Limited Energy Study of Hangar Facilities at Simmons Army Airfield (SAAF), Fort Bragg, North Carolina

Final Report

*RESPONSE TO
INTERIM REVIEW COMMENTS*

*RESPONSE TO
PRE-FINAL
REVIEW COMMENTS*

Figure 1
GAS
DISTRIBUTION PLAN

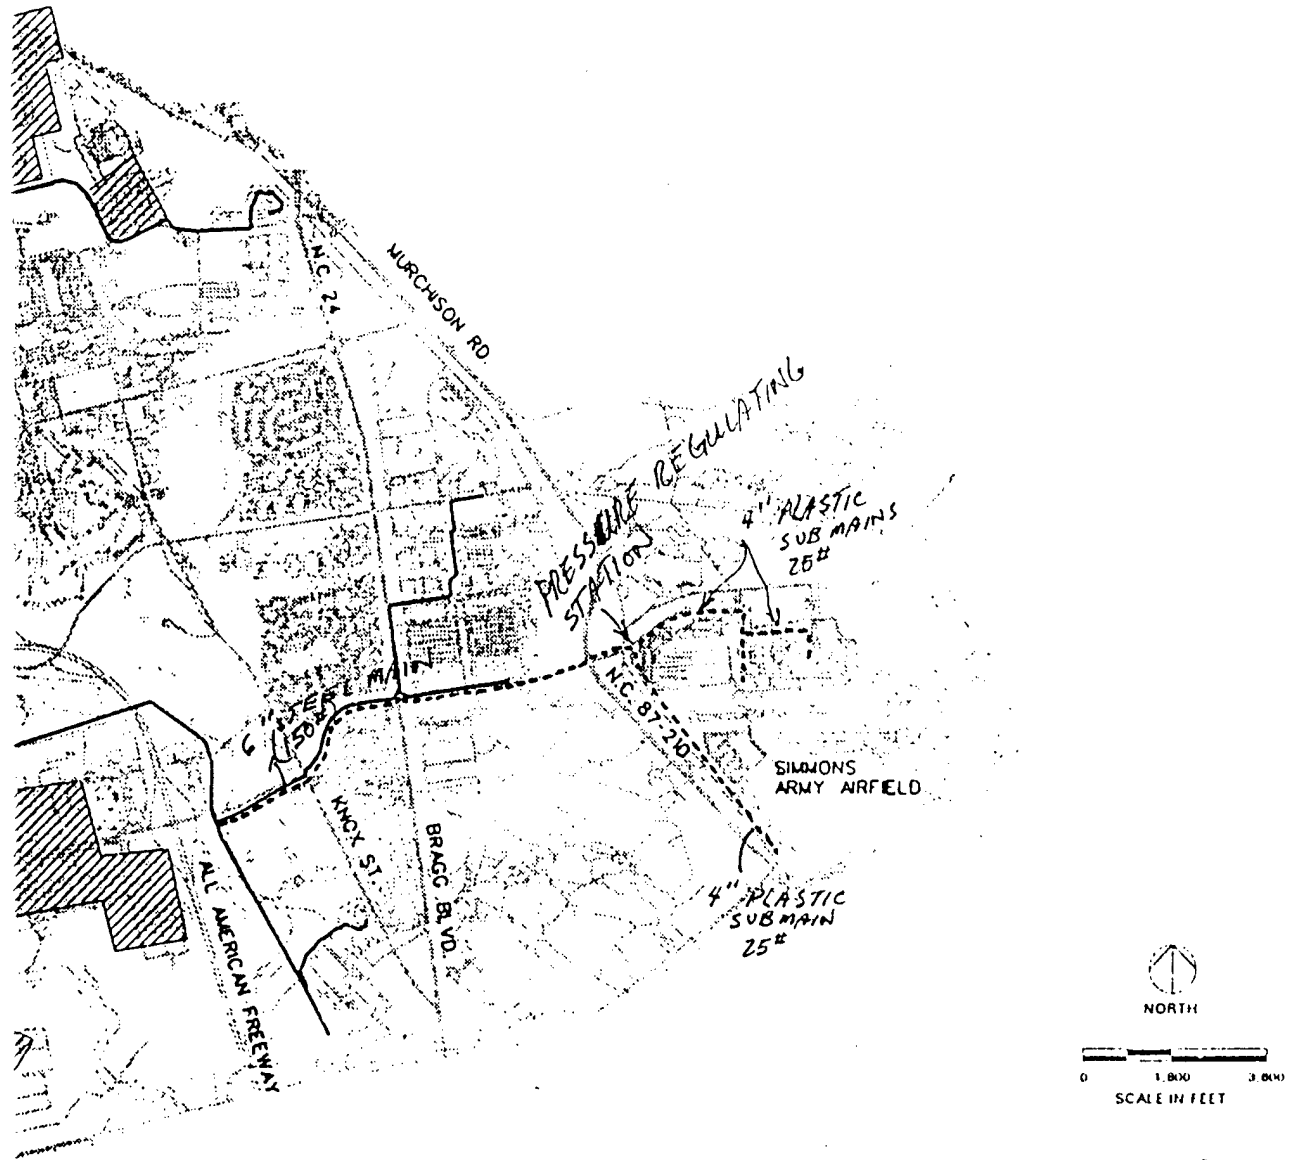
Comment No.	Vol.	Sec.	Page	COMMENTS ☐ Struc. ☐ Arch. ☐ Civ. ☐ Mech. ☐ Elec. ☐ San. ☐ Env. ☐ Fire ☐ Other	Action Code	RESOLUTIONS (include location of documents)	Ref.
1	2	8	4	Costs for pressure testing, overhead, bond, and subcontracting need to be added to cost estimate.	A	Costs have been added to cost estimates.	
2	2	8	4	Sixty psi, 4" line is stated. The gas company states that high pressure (150 psi), steel 6" line should be used to transport that distance.	A	Cost estimates have been revised to incorporate recommended changes by NCNG.	
3	--	--	--	A map showing the proposed gas line routing and distribution is needed.	A	Map has been included in Final submittal. See Section 5.3.2.
